2.15 Structures and Servicing Systems

The information in this section of the reference ABWR DCD, including all subsections, tables, and figures, as modified by the STP Nuclear Operating Company Application to Amend the Design Certification rule for the U.S. Advanced Boiling Water Reactor (ABWR), "ABWR STP Aircraft Impact Assessment (AIA) Amendment Revision 3," dated September 23, 2010 is incorporated by reference with the following departures.

Table 2.15.5c Reactor Building Safety-Related Equipment HVAC System

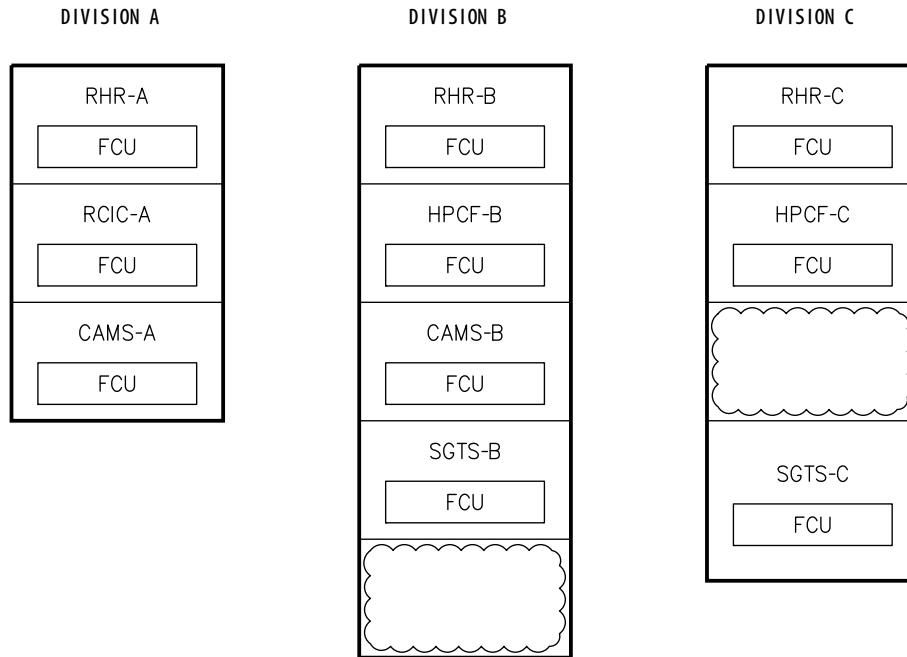
STD DEP T1 2.14-1 (Figure 2.15.10a, Figure 2.15.10j, Figure 2.15.5e, Table 2.15.5c)

Inspections, Tests, Analyses and Acceptance Criteria		
Design Commitment	Inspections, Tests, Analyses	Acceptance Criteria
4. The FGS room FCUs are initiated upon a manual FGS start signal. Not used.	4. Tests will be conducted on each as built FGS room FCU using a simulated initiation signal. Not used.	4. The FGS room FCU starts upon receipt of a signal indicating FGS start. Not used.

Figure 2.15.5e Reactor Building Safety-Related Equipment HVAC System

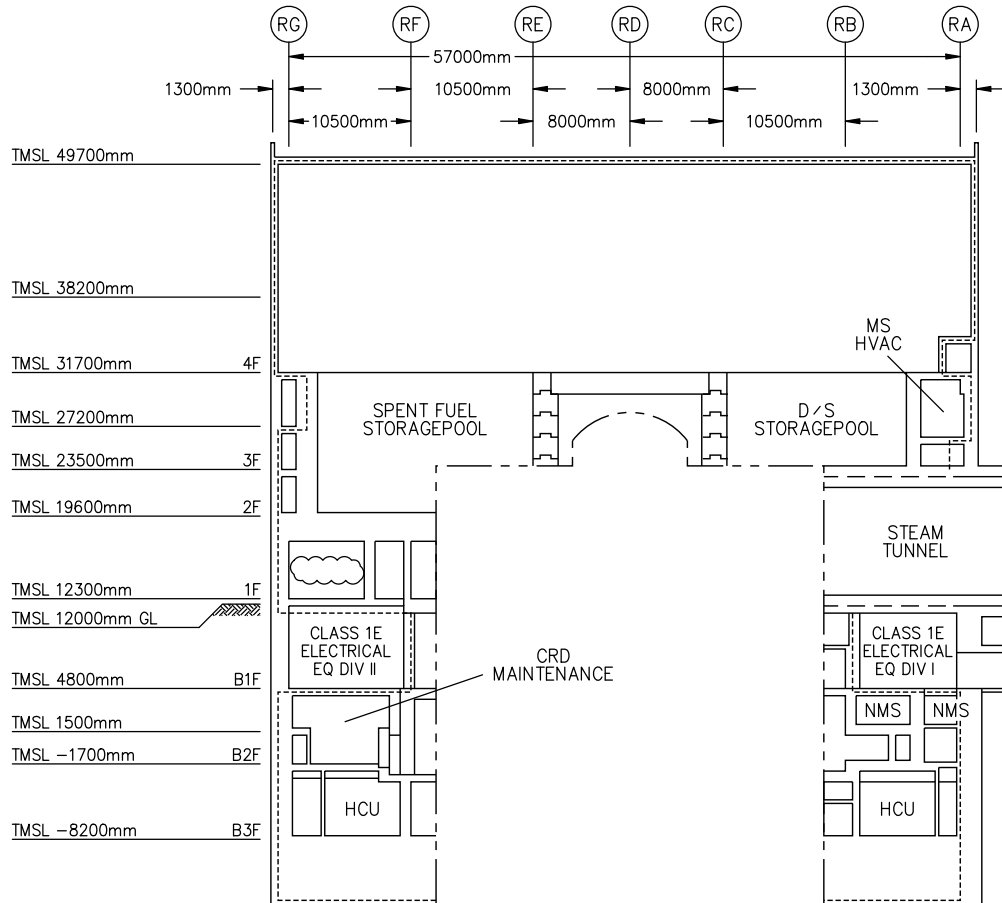
The R/B Safety-Related Equipment HVAC System provides cooling of safety-related equipment areas, and consists of independent fan coil units. Figure 2.15.5e shows the basic system configuration and scope.

The Residual Heat Removal (RHR) System, High Pressure Core Flooder (HPCF) System and Reactor Core Isolation Cooling (RCIC) System pump room FCUs are automatically initiated upon startup of their respective room process pump. The Containment Atmospheric Monitoring System (CAMS) and Standby Gas Treatment System (SGTS) room FCUs are automatically initiated upon isolation of the Reactor Building Secondary Containment HVAC System. ~~The Flammability Control System (FCS) room FCUs are also initiated upon a manual FCS start signal.~~

Figure 2.15.12a Control Building Arrangement, Section A-A

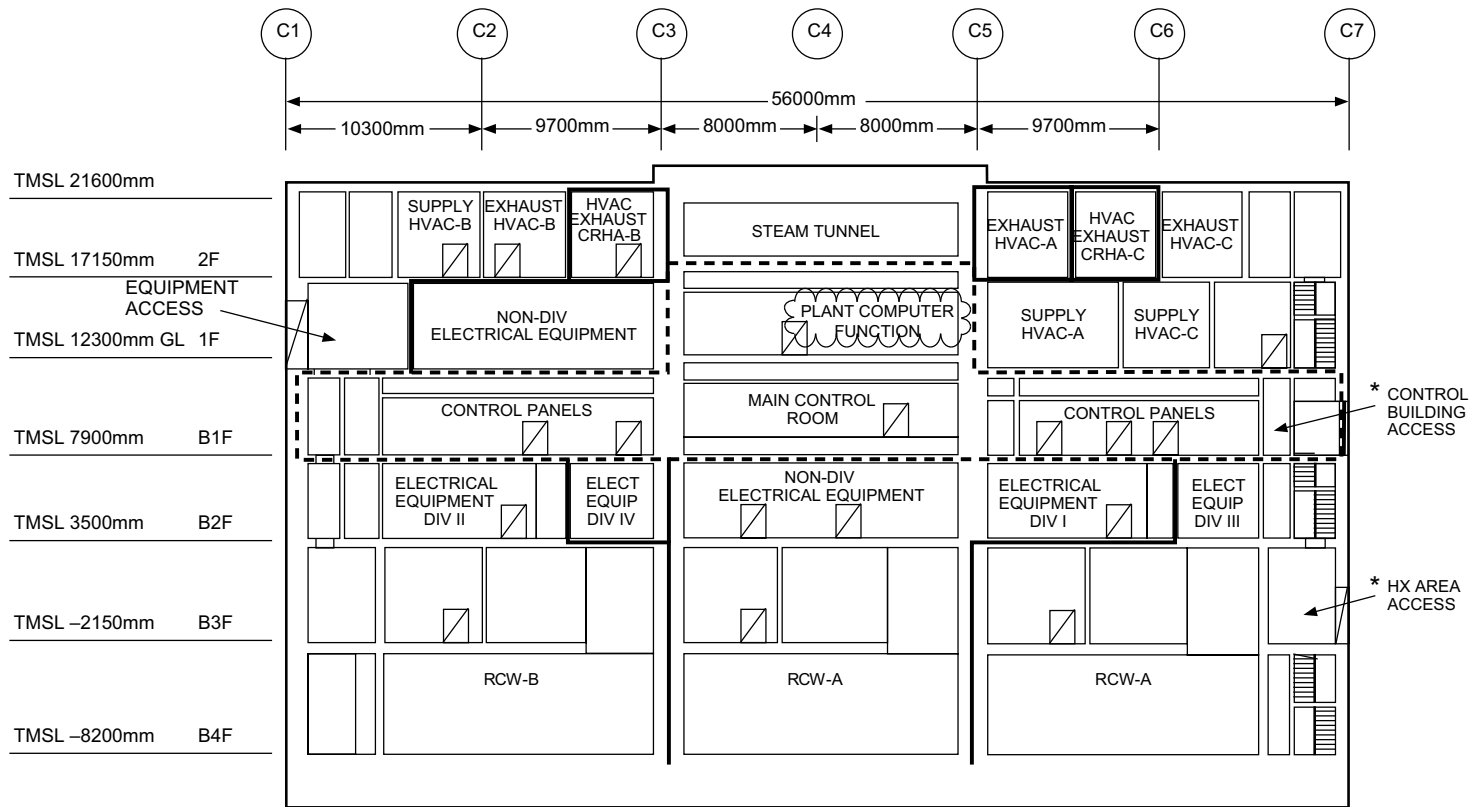
STD DEP T1 3.4-1 (Figure 2.15.12a, Figure 2.15.12b, Figure 2.15.12g)
